**PRODUCT
SUPPORT
BULLETIN # 370**

9070-20, 9071-20, 9075-20 Impact Wrench, sold between March, 2001 & June, 2001

SUBJECT: - PRODUCT SAFETY -

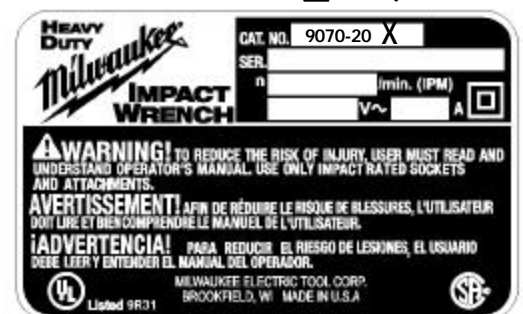
Stamp or etch an '**X**' on the tool's nameplate next to the catalog number after installation of a replacement **31-17-0270 Cord Clamp**.

The '**X**' will show that the impact wrench has been repaired.

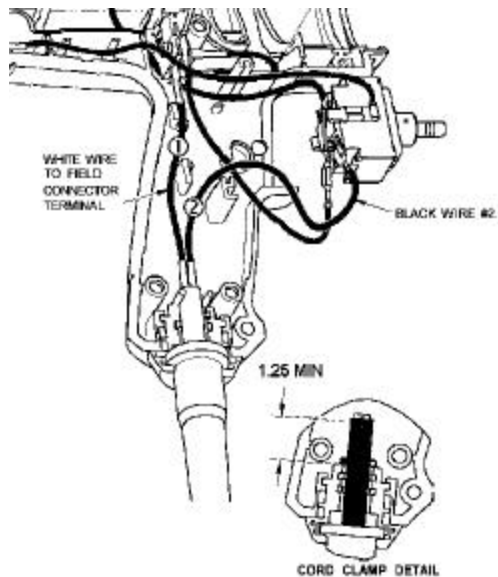
Wiring specification has been modified increasing the length of cord inserted through the strain relief, cord clamp and into the handle from .25" beyond top of cord clamp to 1.25" [see *illustration*].
